SUBJECT: VERMONT YANKEE NUCLEAR POWER STATION – GROUND WATER
MONITORING INSPECTION REPORT 05000271/2010006

Report No.: 05000271/2010006

IR 05000271/2010006; 01/25/2010 – 04/14/2010; Vermont Yankee Nuclear Power Station; Ground Water Protection Initiative Inspection.

Figure 1
Vermont Yankee Tritium Ground Water Plume

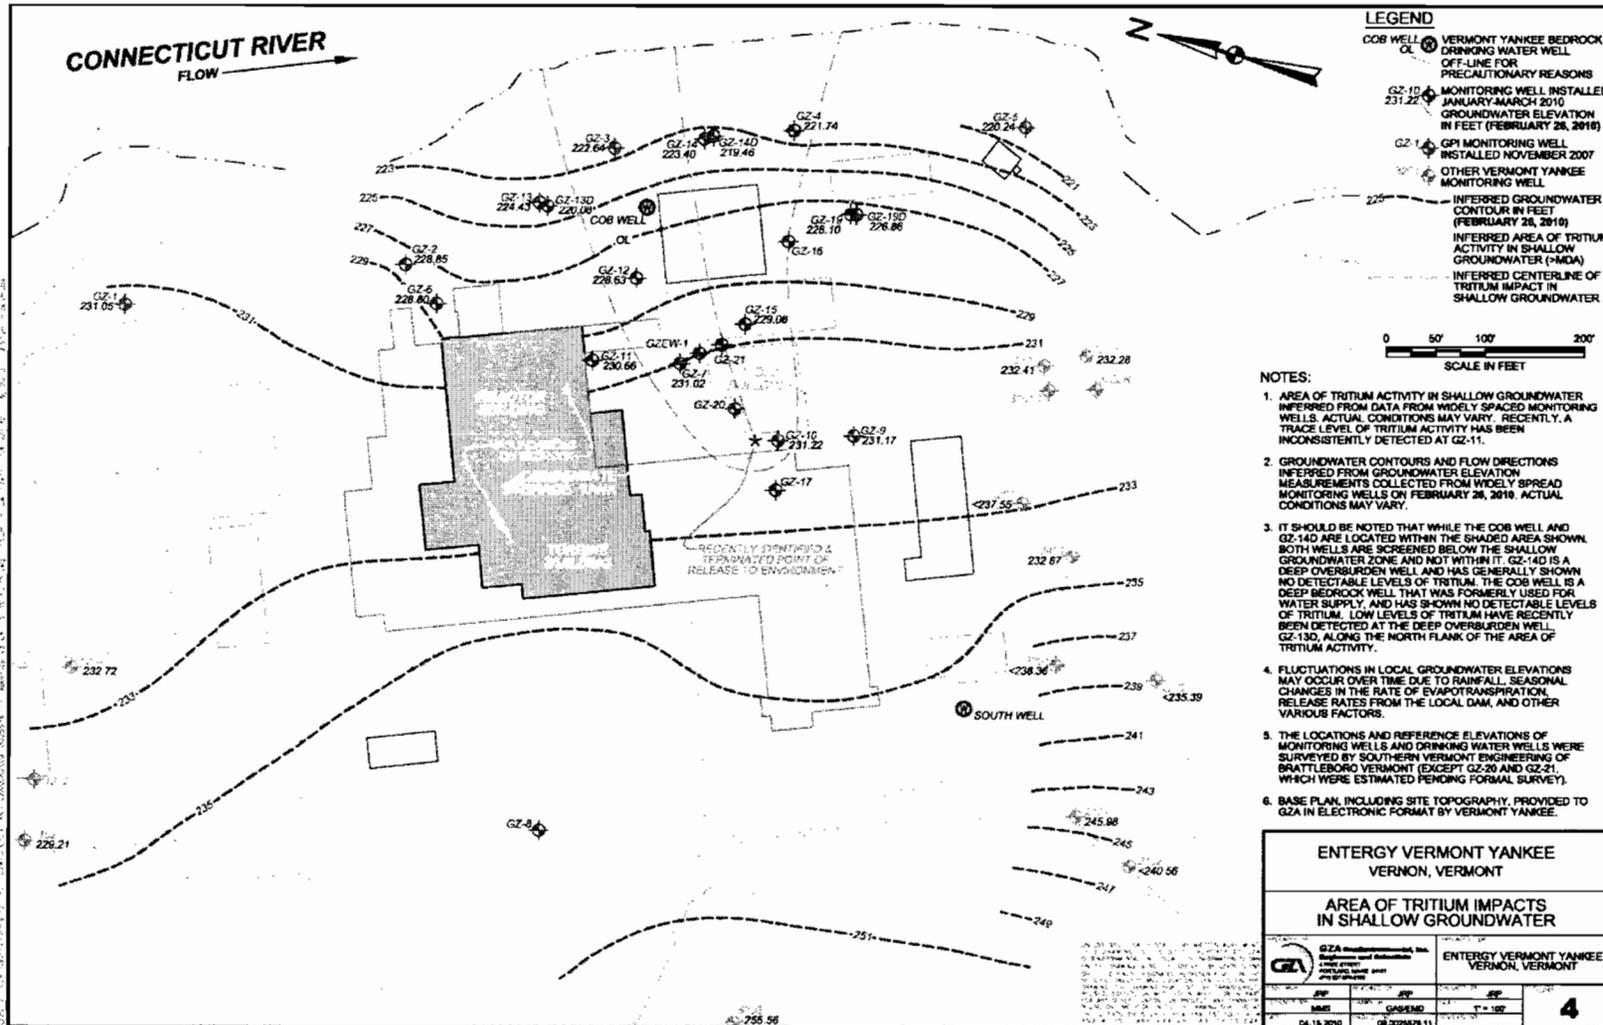
A review of the onsite ground water monitoring results defined a tritium plume, as depicted in Attachment A, Figure 1, which emanated at the AOG pipe trench leak location and extended in an easterly direction 400 feet to the Connecticut River (Vernon Pond). The tritium plume followed the ground water flow gradient and spread out to a shoreline frontage of approximately 300 feet width. The tritium plume was approximately 5 – 9 feet thick in the overburden material which was within 30 feet of the ground surface and overlay the bedrock aquifer. The existence of the plume was assumed to be recent based on an initial low-level tritium concentration first detected in the ground water monitoring well GZ-3 on November 17, 2009. This initial detection indicated the ground water contamination plume had just reached the site perimeter at that time since there had been no detectable contamination in any previous samples taken from GZ-3 or any of the other site perimeter ground water monitoring wells. Since the identification of ground water contamination in January 2010, ENVY installed additional ground water monitoring wells at various depths to determine the extent of the contamination; identify the source location; and provide ground water flow and radionuclide concentration measurements to support the calculation of the amount of

In January 2010, the NRC determined that the licensee's subsurface CSM of the Vermont Yankee (VY) site, which had been developed in response to the NEI 07-07 Ground Water Protection Initiative (GPI), was not sufficiently detailed. The NRC found the CSM did not initially provide sufficient specificity to identify the source area for the H-3 (tritium) leak, or include fundamental definition of the ground water flow units (e.g., depths and extents), or their hydraulic relationships and parameters. Based upon hydrogeologic investigations begun in response to the tritium leak, ENVY significantly updated the CSM to account for site-specific ground water flow and transport processes, properties and conditions.

The initial detection of the tritium leak was in monitoring well GZ-3 (see Attachment A, Figure 1) located on the Connecticut River bank, but its source was not readily discernable due to an absence of monitoring wells adjacent to the plant systems, structures and components (SSCs) containing radioactive fluids, as recommended in the GPI. ENVY examined numerous candidate SSCs for possible sources and then installed a series of ground water monitoring wells to aid in identifying the tritium leak source. By February 6, 2010, monitoring well GZ-10 was installed next to the Advanced Off-Gas (AOG) building where subsurface pipes conveyed fluids carrying radionuclides. GZ-10 monitoring data helped to determine the specific leak location. The initial tritium concentration at GZ-10 was approximately 2.5 million pCi/l. The leakage was confirmed to be from an underground concrete pipe vault associated with the AOG system, as described in section 4OA2 of this report.

The updated CSM provided detailed information on the additional investigation well locations, tritium concentrations sampled over time, and water-table levels (see Attachment A, Figure 1). The updated CSM also provided vertical definition and spatial relationships for the subsurface overburden units. This information was important in determining where and at what depth to install the remediation well.

In order to ensure sufficient monitoring of this hydraulic protection for the duration of the plume extraction and attenuation processes, and of any future leaks to the ground water, the following issues were identified by the NRC to address the remaining information gaps and technical uncertainties affecting the continued viability of ENVY's current Conceptual Site Model. These issues were discussed with ENVY, who agreed to evaluate the following actions to provide further clarity and confidence in providing accurate ground water flow and tritium contaminant transport results, and to assure protection of the drinking water aquifer beneath the site:

- An evaluation of ground water flow relationships between the overburden units and bedrock aquifer;
- An evaluation of hydraulic ground water relationships between the water table and bedrock aquifer, and the influence of the Vernon Pond water level (created by the Trans-Canada hydroelectric dam on the Connecticut River).

- Continued mapping and evaluation of the subsurface effects of structures, systems and components (SSCs) (e.g., process pipe vaults and trenches, tanks and subsurface drains) on ground water flow directions and rates that influence the migration of the residual tritium plume and potential future releases.

The NRC tracked the tritium plume evolution and migration pathway using monitoring data from the investigation monitoring well network as shown in Attachment A, Figure 1. Time-series trend data of tritium concentrations in monitoring wells GZ-10, 20 and 21 showed the highest concentration area (i.e., centroid) of the tritium plume had migrated from GZ-10 towards the Connecticut River. To date, tritium concentrations in monitoring well GZ-10 have dropped significantly from the original value of approximately 2.5 million pCi/l to less than detectable levels. GZ-10 is adjacent to the original detected source (i.e., leakage from an underground concrete pipe vault associated with the AOG system to the overburden unit). This plume movement was also illustrated by the tritium concentrations in GZ-14, down-gradient of the initial source, showing a consistent increase from approximately 63,000 pCi/l, initially, to above 253,000 pCi/l on April 27, 2010.

The plume follows the water table gradient and shows the effects of subsurface foundations and variability in the overburden thicknesses. Tritium concentrations in GZ-3, where the plume was first detected, had shown an increasing trend to 97,000 pCi/l sampled on April 26, 2010, indicating that the highest concentration of the leak had not yet reached the River. The highest concentration of tritium for GZ-21 (2,028,000 pCi/l on April 7, 2010) has since subsided to 864,000 pCi/L on April 27, 2010, which indicated the centroid of the plume has moved passed this monitoring well and northeast towards the Connecticut River. To better understand the plume’s behavior and to estimate concentrations down-gradient, the numerical model being developed by ENVY may provide estimated release rates and travel times to the river. The greatest potential impact on health and safety of the public would be if tritium could migrate to the bedrock aquifer. Hence, the licensee has initiated seasonal monitoring data and numerical simulations, which should help determine the conditions influencing this undesirable migration scenario.
